INVESTIGATION FOR SOUTH FILL AREA UNITED STATES MILITARY ACADEMY WEST POINT, NEW YORK

Final Report

76. The consultants' review comments concerning this report are presented without comment in Appendix F.

Figure 16. Dissipation of excess pore pressures with time, South Fill area

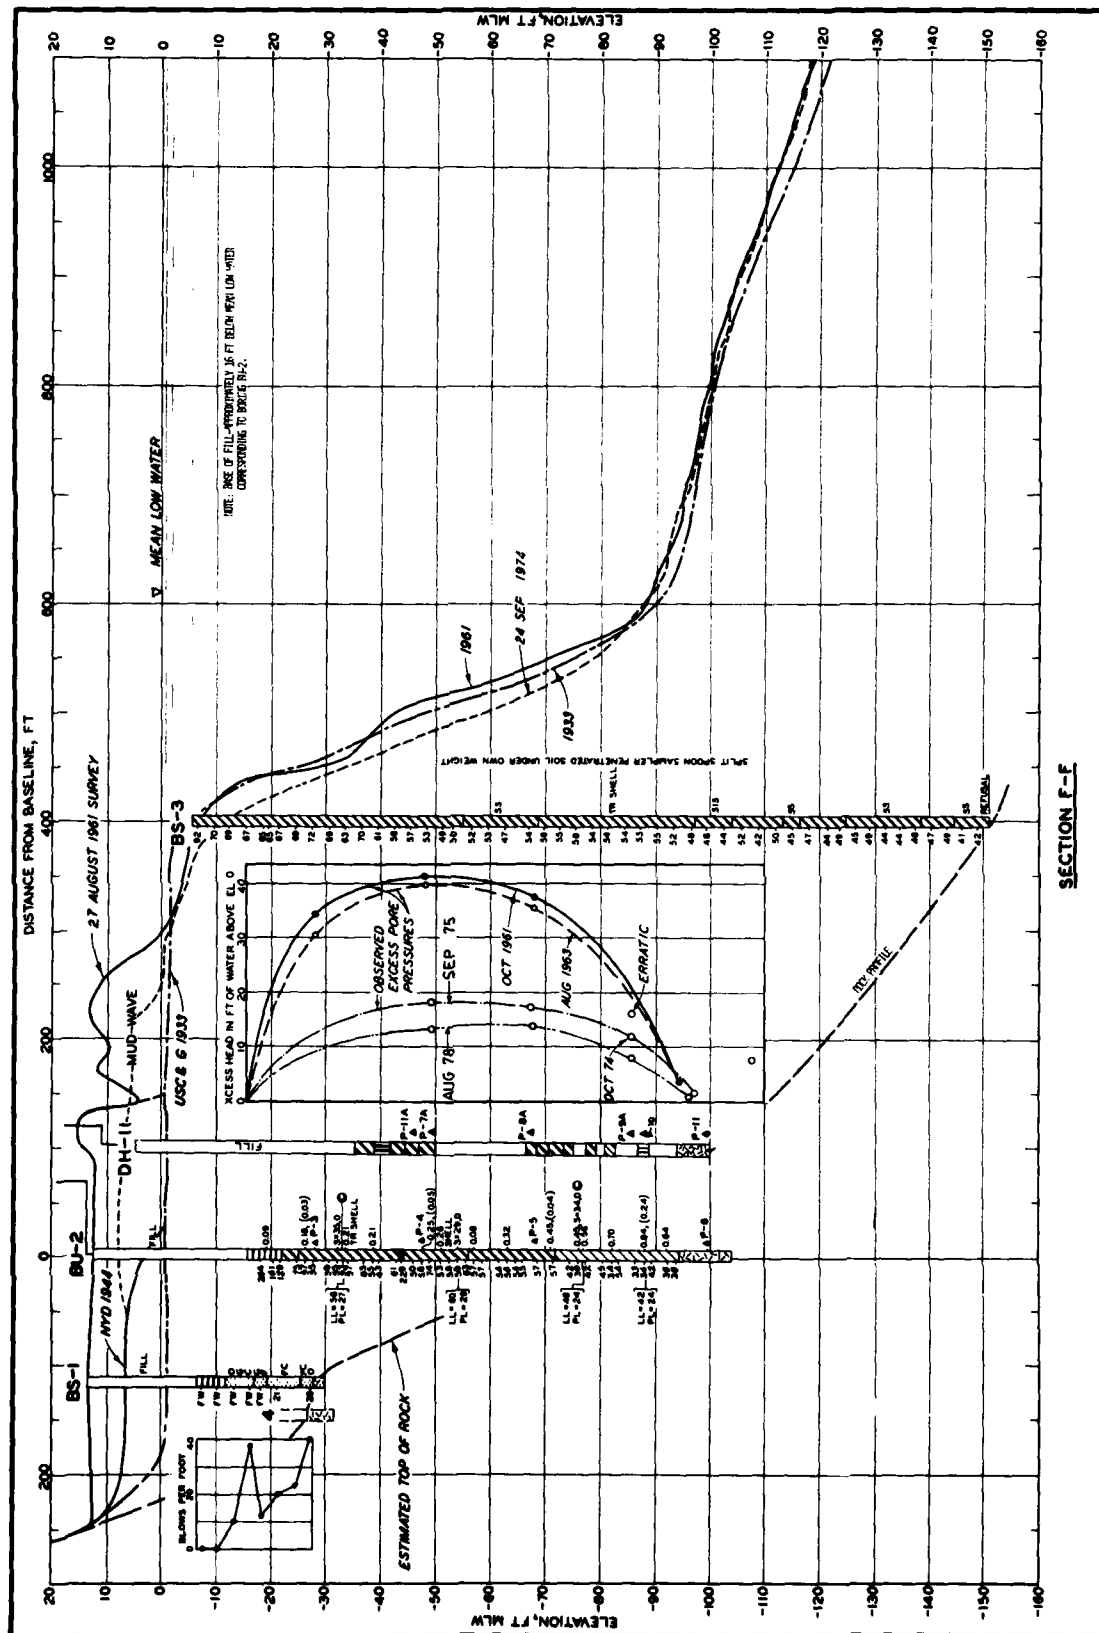
The piezometers also encountered difficulties requiring discontinuation of readings or replacements. However, enough readings have been obtained to produce an excellent plot of the dissipation of excess pore water pressures with time at one location shown on Fig. 14. The excess pore water pressures after 1973 apparently are shown only by piezometers P-7A, P-8A, P-9A and P-11. It would be helpful to the reader of this report if the specific location, depth to rock and reason for showing zero excess head of water at about Elev. -16 were stated on the figure or in the report in the section of Groundwater Conditions.

Figure 21. Inclinator data

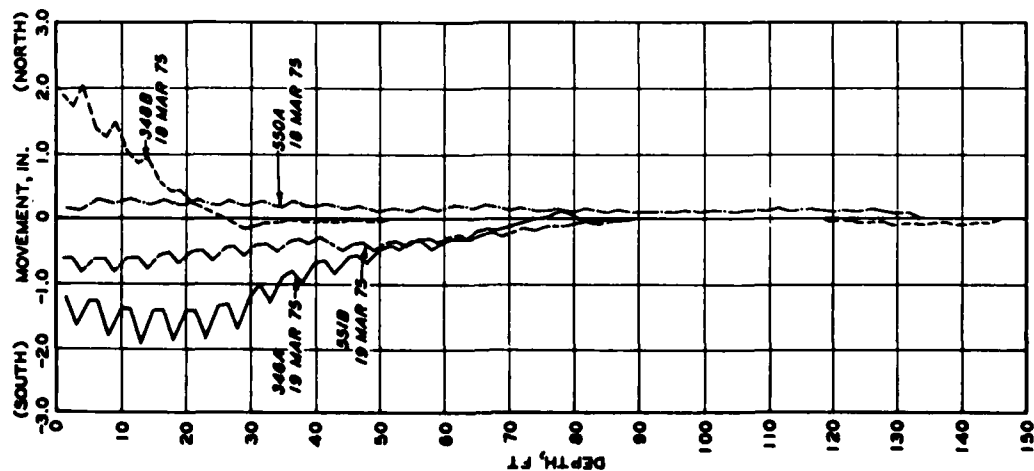
It is unfortunate but understandable under the condition of large settlements that so much difficulty was encountered with the inclinometers installed at various times thru the South Fill. I note that the inclinometers for which data are plotted in Fig. 19 were installed at different times varying from Nov. 1967 and March 1968 to Sept. 1972. Hence the motions to March 1975 are not directly comparable. This should be noted on the figure.
